METROPOLITAN PLANNING COMMISSION STAFF REPORT- MARCH 16, 2016

Agenda Item No: 13

ZONING REQUEST & PRELIMINARY SITE PLAN AILLET, FENNER, JOLLY & MCCLELLAND, INC. CASE NO. C-6-16: District: G/Bowman Applicant: District: 12/Epperson

R-A & R-A (SPI-2) to I-1 (PUD) with Preliminary Site Plan Approval Industrial Park with Distribution, Warehouse & Manufacturing Facilities Requešt: Proposed Use:

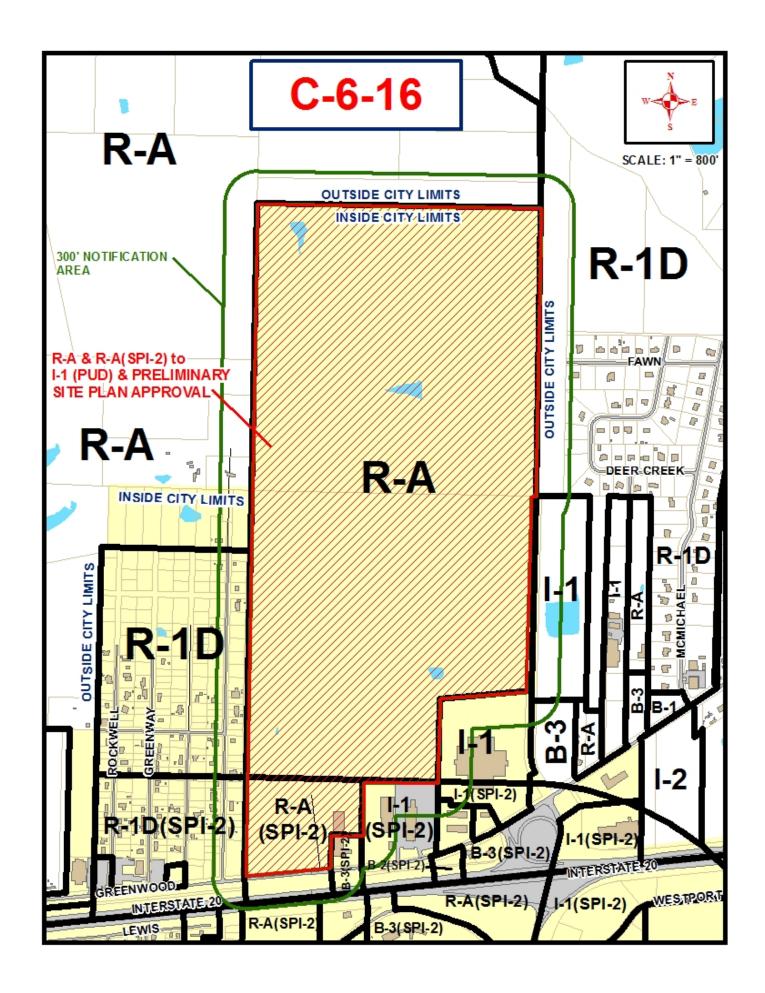
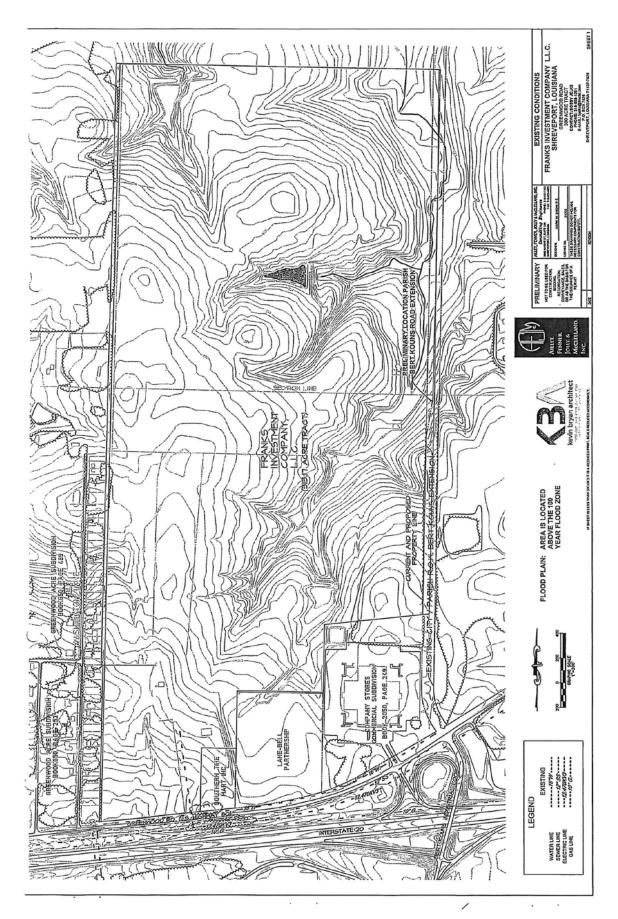
The submitted preliminary site plan shows a two phase development across the 313.17 acre site, which is comprised of two unplatted tracts of land, and will include two distribution/warehousing/manufacturing facilities. The proposed development includes a total of 2,456,320 sq. ft. of gross floor area. The first phase of construction will include a 1,440,580 sq. ft. facility, approximately 4,898 parking spaces, and a detention point of an undetermined size on the front 193.15 acres of the property. The second phase of construction will include a 1,015,740 sq. ft. facility, approximately 2,742 parking spaces, and two large detention ponds (1.5 acres and 1.7 acres, respectively) on the rear 120 acre portion of the site.

As previously noted, the applicant intends to create over 7,600 parking spaces. Per sec. 106-1338(7), warehousing and As previously noted, the applicant intends to create over 7,600 parking spaces. Per sec. 106-1338(7), warehousing and industrial uses in excess of 10,000 sq. ft. require three parking spaces per employee. When the range of jobs anticipated at the site are considered (1,600-4,000), the resulting parking requirement ranges between 533 and 1,333 parking spaces. By comparison, the site is excessively over-parked given the proposed uses and represents a significant and unnecessary amount of impervious surfacing. Staff did a comparison study (refer to PUD Application Assessment) in which this site was compared to similar sites with similar end users (i.e. Amazon) and found that the end-user selected sites with significantly less parking. From this analysis, staff concluded that: (1) much of this parking would be under-utilized, (2) excessive, unusable parking is not likely to be seen as an attractive quality, (3) may be considered an inefficient use of space, and (4) significantly increases the impervious paving at the site, which requires additional storm water management controls. Staff advised the applicant of the above conclusions in a written report, along with recommendations for revision, including the addition of another building to better maximize space at the site. However, the applicant elected to keep the original design. Per the preliminary site plan, the applicant has proposed three detention ponds at the site as a means to mitigate the impact of the increased storm-water run-off applicant has proposed three detention ponds at the site as a means to mitigate the impact of the increased storm-water run-off at the site.

It should also be noted that the proposed UDC, which reflects a standard that is comparable to modern ordinances in other cities, would still require less parking than what is reflected in the current site plan. At 1 space per 500 sq. ft. for industrial uses, the required parking would be 4,912 spaces and at 1 space per 10,000 sq. ft. of warehousing space, the requirement would be 246 spaces. Both estimates fall far short of the 7,600 spaces proposed by the applicant.

Development of the subject property shall be in substantial accord with the approved preliminary site plan; Approval of the requested uses along with the proposed site amenities as documented in this report; Provide a revised preliminary site plan designating the size of the detention pond and the width of the wooded buffer located at the southern end of the property (Phase 1); Provide a Traffic Impact Assessment (TIA) as required by LADOTD and official documentation of the approved Bert Kouns Industrial Loop extension and the improvements to Geenwood Rd.as a part of any future final site plan submittals for this property: submittals for this property;
